Estrella Substation and Paso Robles Reinforcement Project

HWT Response to CPUC Data Request No. 3

Request #4:

Figure 2 – N-1: Paso Robles-Templeton 70 kV

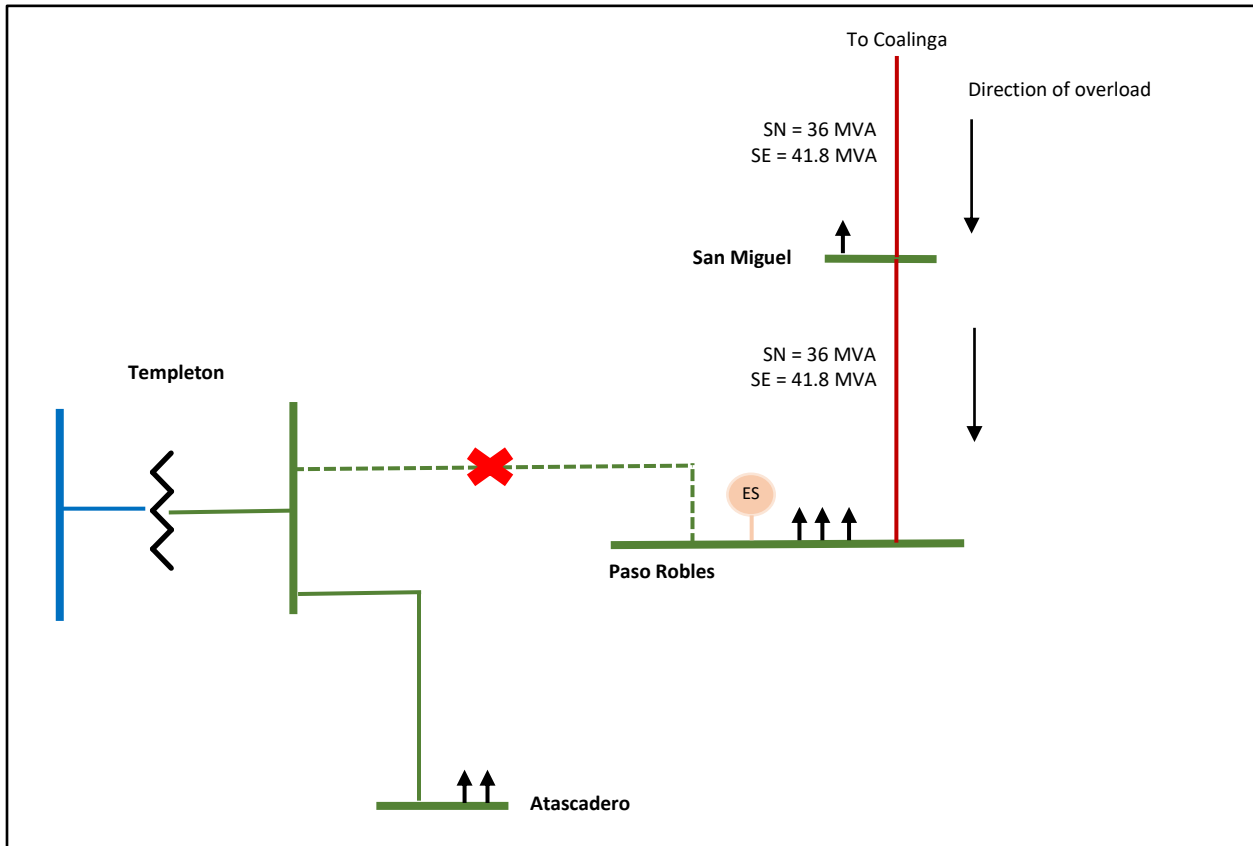
Figure 2 below outlines the outcome of the critical contingency, Paso Robles-Templeton 70 kV, on the Paso Robles Distribution Planning Area. This P1 outage generates an overload to the San Miguel-Paso Robles 70 kV line and Coalinga #1-San Miguel 70 kV line during any assumed loading conditions of the existing system. The magnitude of the overload on the San Miguel-Paso Robles 70 kV line and Coalinga #1-San Miguel 70 kV line is significant and dependent on the amount of charging proposed (123 MW) plus any off-peak load at Paso Robles. For an outage of the Paso Robles – Templeton 70 kV line, the energy storage facility and the Paso Robles total load cannot exceed 41.8 MVA. By observation, the proposed energy storage far exceeds this limit on its own without accounting for Paso Robles 70 kV off peak load.

Figure 3 – N-2 Gates-Templeton and Morro Bay-Templeton 230 kV lines

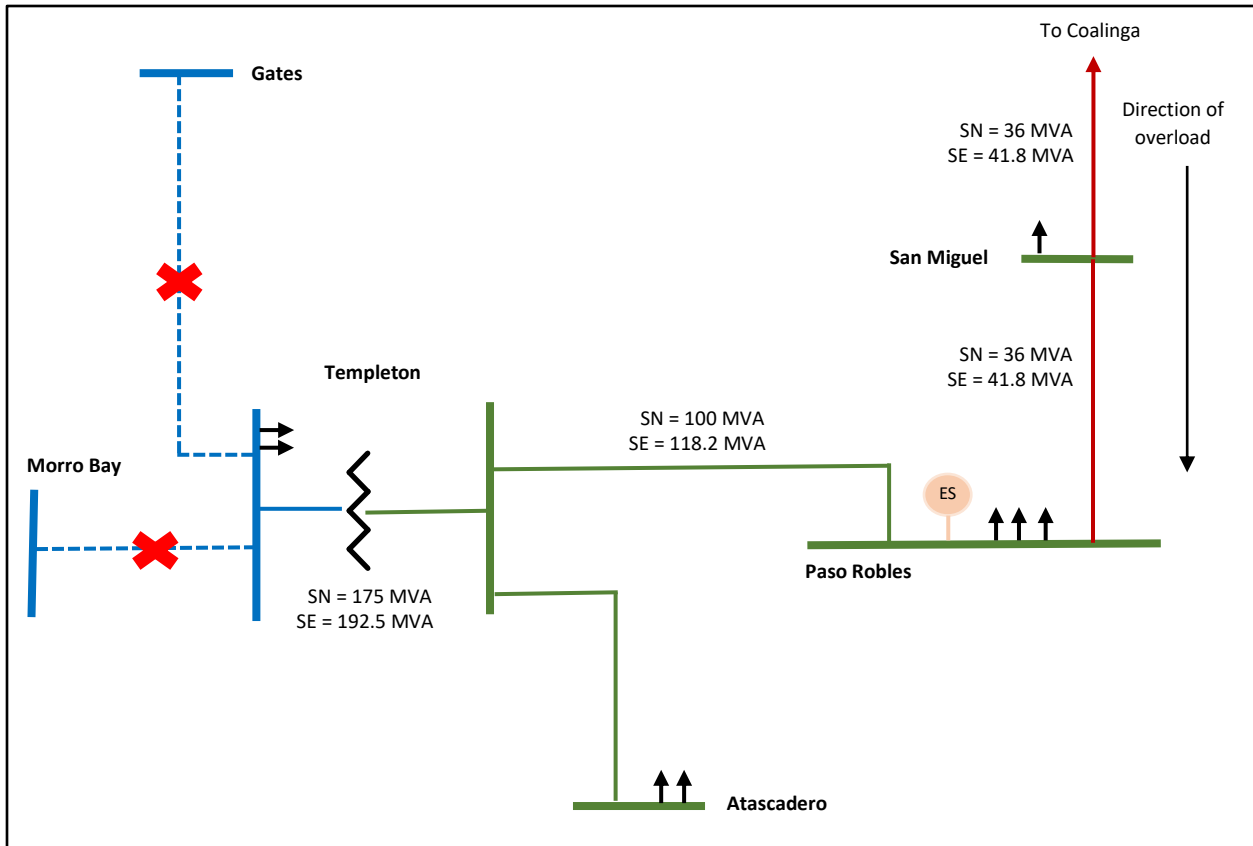
Figure 3 below outlines the outcome of the critical contingency, Gates-Templeton combined with Morro Bay-Templeton 230 kV lines, on the Paso Robles Distribution Planning Area. This outage generates an overload to the San Miguel-Paso Robles 70 kV line and Coalinga #1-San Miguel 70 kV line during any assumed loading conditions of the existing system. The magnitude of the overload on the San Miguel-Paso Robles 70 kV line and Coalinga #1-San Miguel 70 kV line is significant and dependent on the amount of charging proposed (123 MW) plus any off-peak load at Paso Robles. For an outage of the Gates-Templeton combined with Morro Bay-Templeton 230 kV lines, the energy storage facility and the Paso Robles, Templeton, and Atascadero load cannot exceed 41.8 MVA. By observation, the proposed energy storage far exceeds this limit on its own without accounting for Paso Robles 70 kV off peak load.

Figure 4 - P1 Paso Robles-San Miguel 70 kV

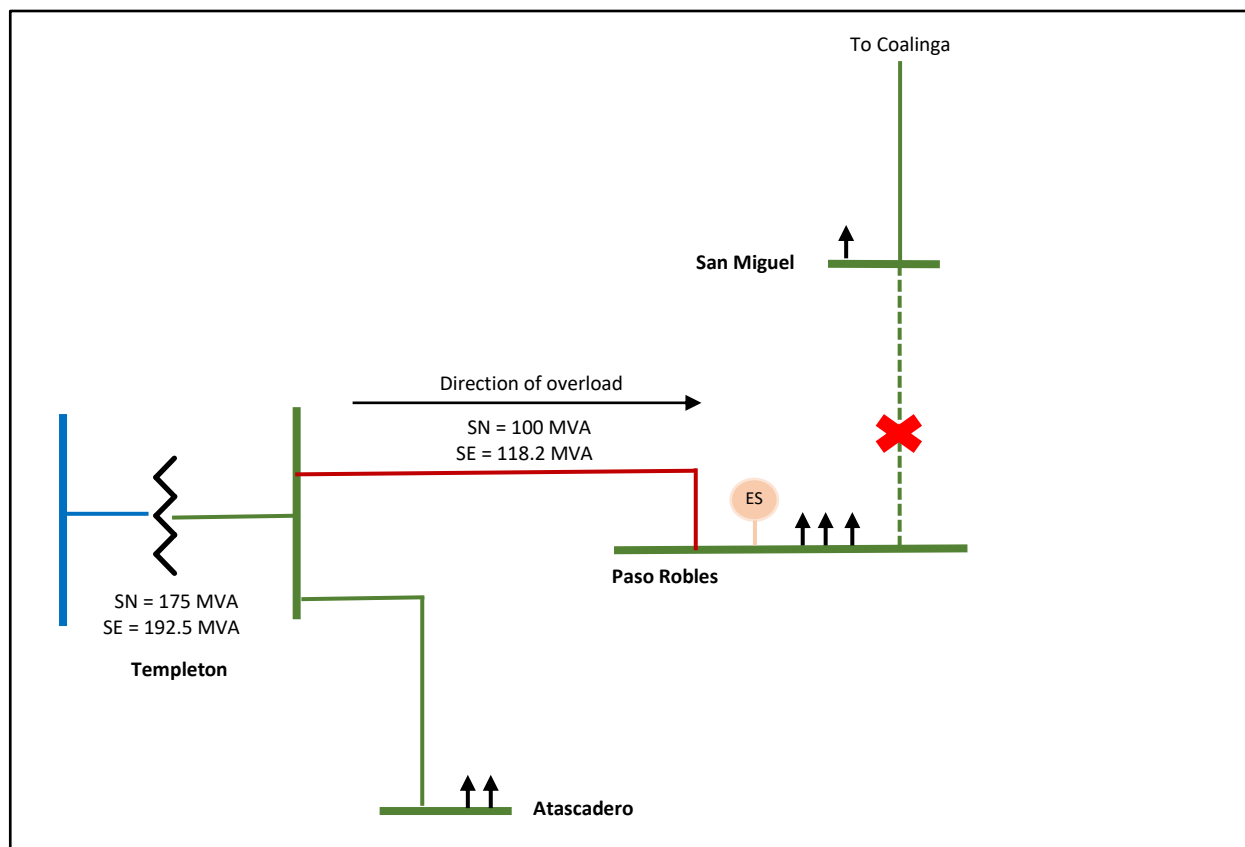
Figure 4 below outlines the outcome of the San Miguel-Paso Robles 70 kV line on the Paso Robles Distribution Planning Area. This N-1 outage generates an overload to the Templeton-Paso Robles 70 kV line. For an outage of San Miguel – Paso Robles 70 kV line, the magnitude of the overload on the Templeton-Paso Robles 70 kV line is driven by the amount of charging proposed (123 MW) plus the local load at Paso Robles. The total of these two values are required to be less than 118 MVA, which the energy storage exceeds on its own, even without accounting for any Paso Robles 70 kV off-peak load.
